SITE PLAN REVIEW

LOT NO. 28 REGISTERED PLAN 43M-2013

LOT GRADING PLAN  
55 DEGREY DRIVE

Project: DEGREY DRIVE,  
CITY OF BRAMPTON

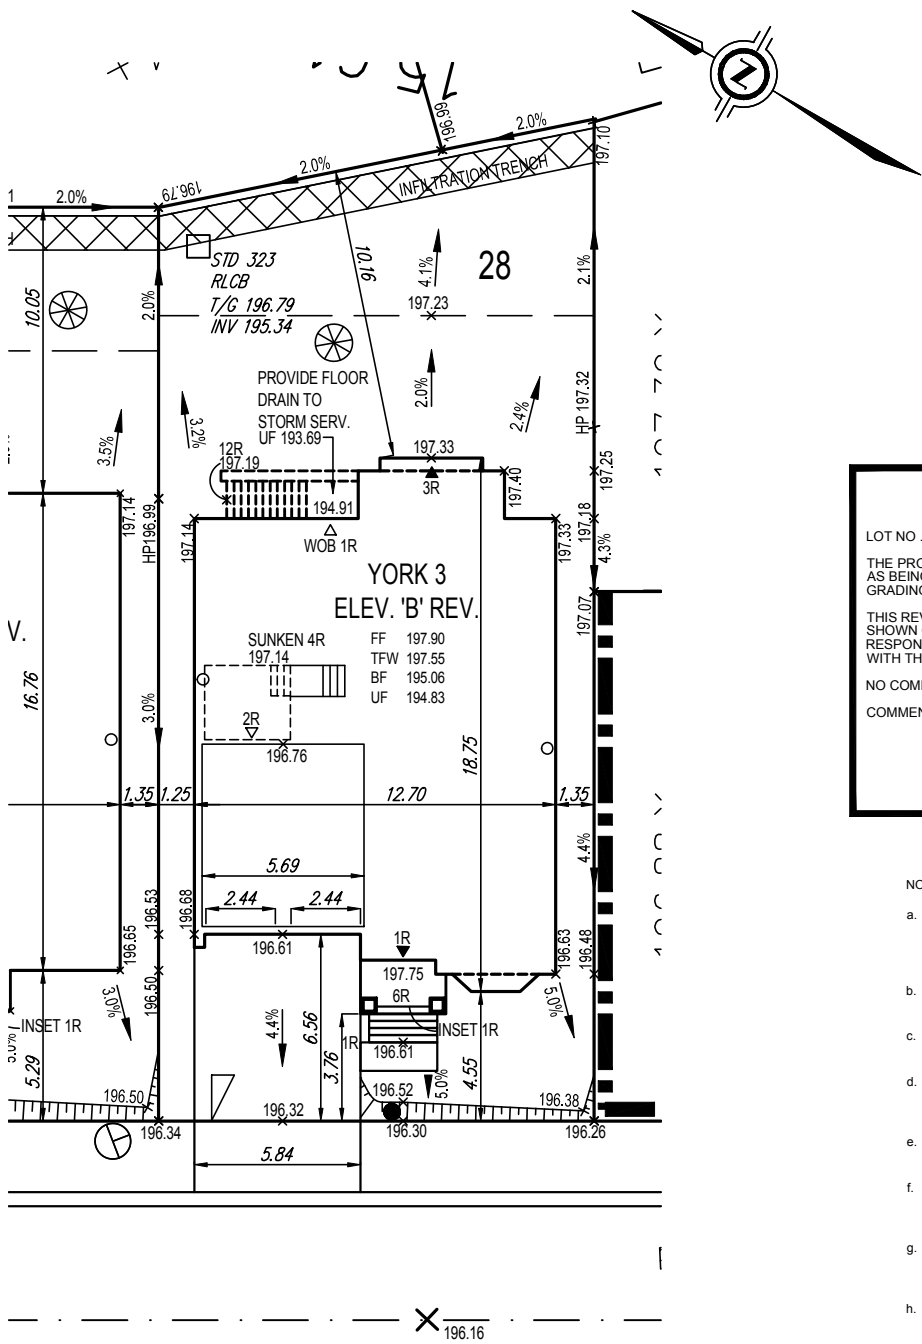
THE PROPOSED LOT GRADING AND DRAINAGE IS APPROVED AS BEING IN CONFORMITY WITH THE OVERALL APPROVED GRADING PLANS FOR THE SUBDIVISION.

COMMENTS AS NOTED
